**Gatten Subdivision
2024 Replat**

**ITEM #6 - PRELIMINARY PLAT
GATTEN SUBDIVISION 2024 REPLAT**

KPB File No.	2023-136
Plat Committee Meeting:	January 8, 2024
Applicant / Owner:	Glendale Croom of Sterling and Jon Hill of Sterling
Surveyor:	John Segesser / Segesser Surveys
General Location:	Patty Ave in Sterling AK

STAFF REPORT

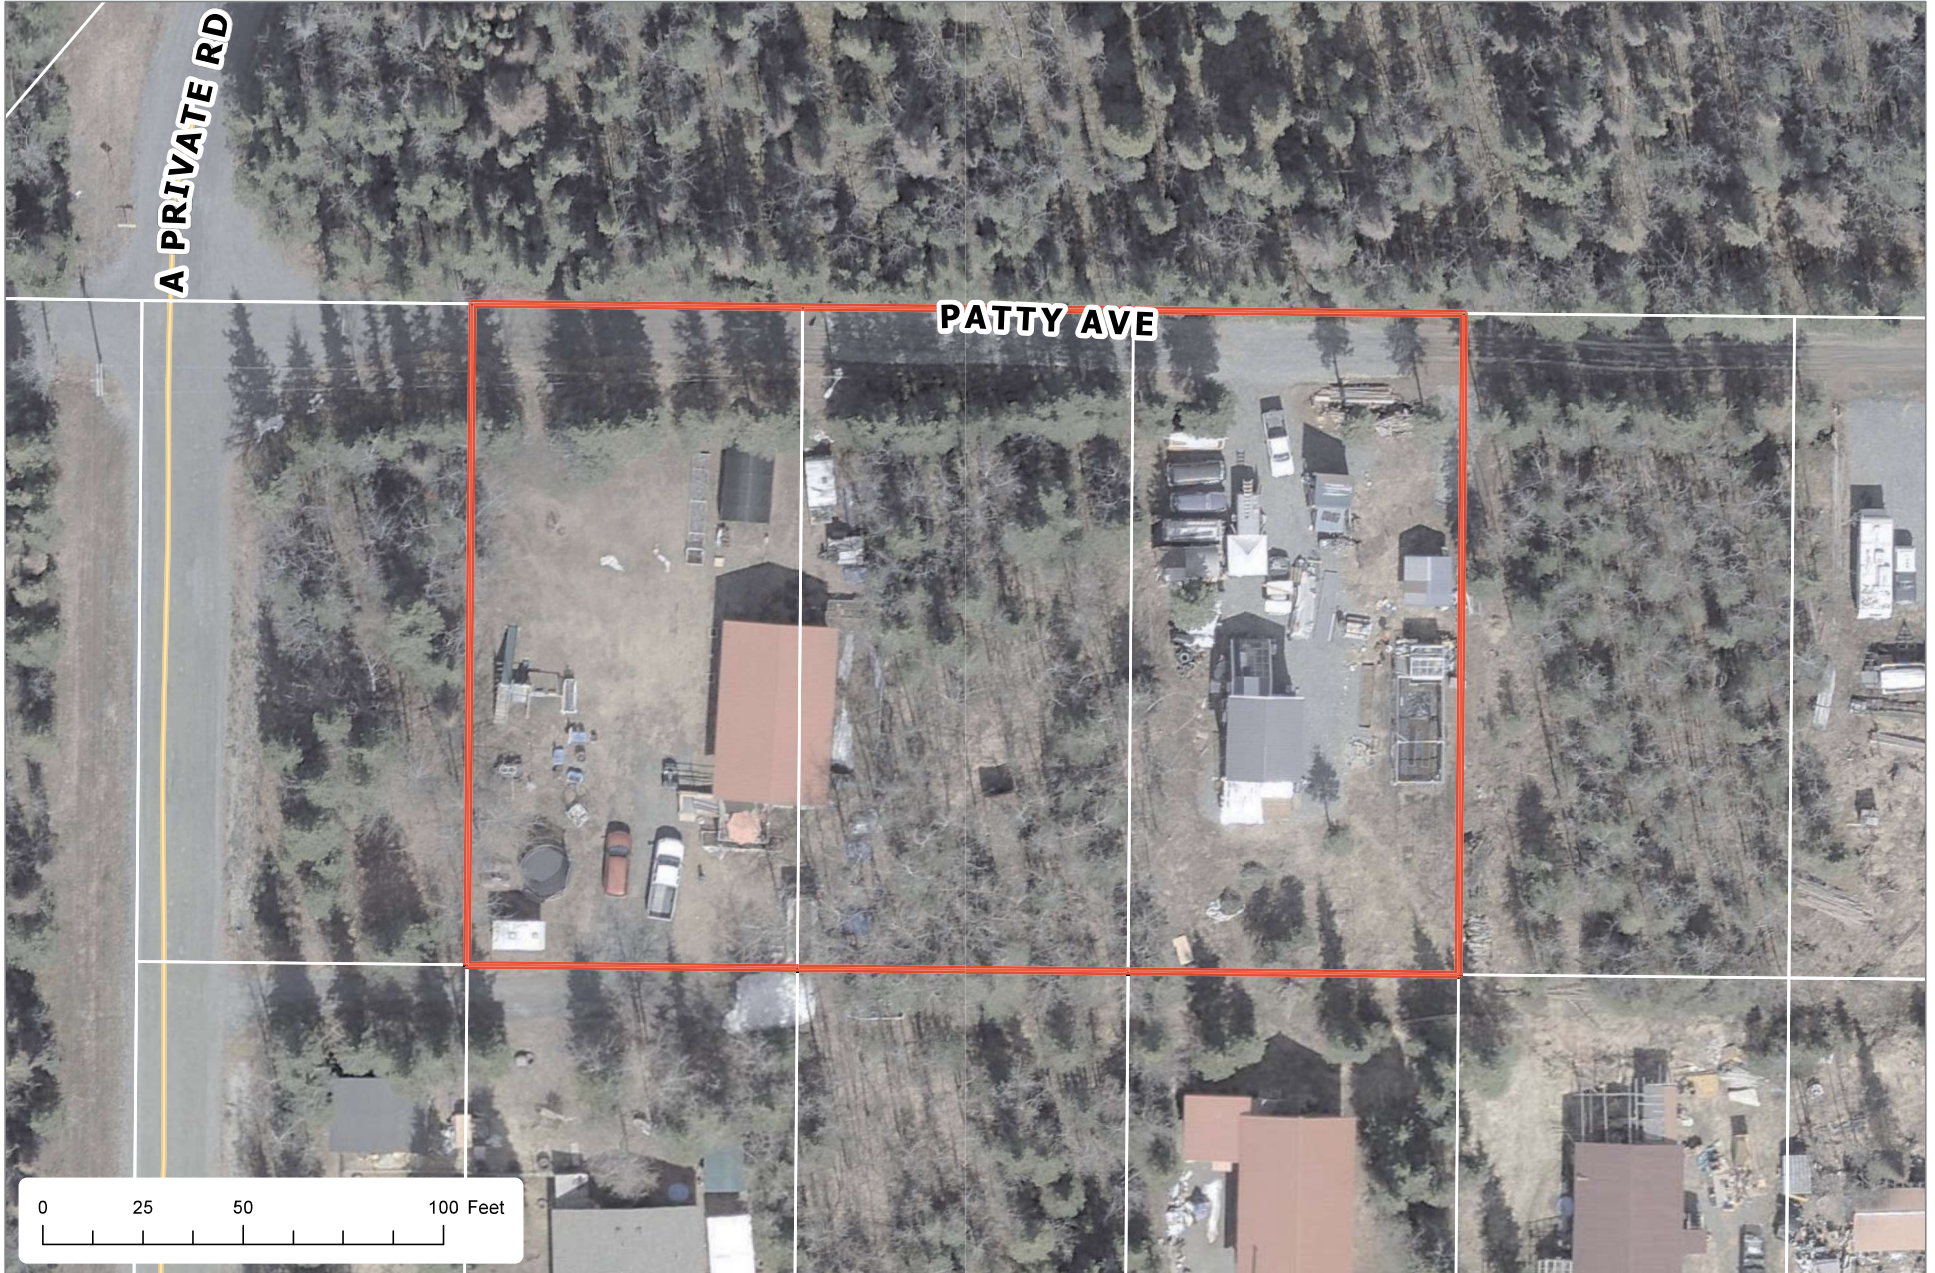
Add record dimensions to the drawing.

Add to KPB File No '2023-136'
Check spelling in the legal description

Show and label A Private Rd to the northwest.

Alley should be a 10' easement per K-995

Add Certificate of Acceptance to final

Add date of January 8, 2024 to Plat Approval

Tie the subdivision to closest BLM / GLO corner
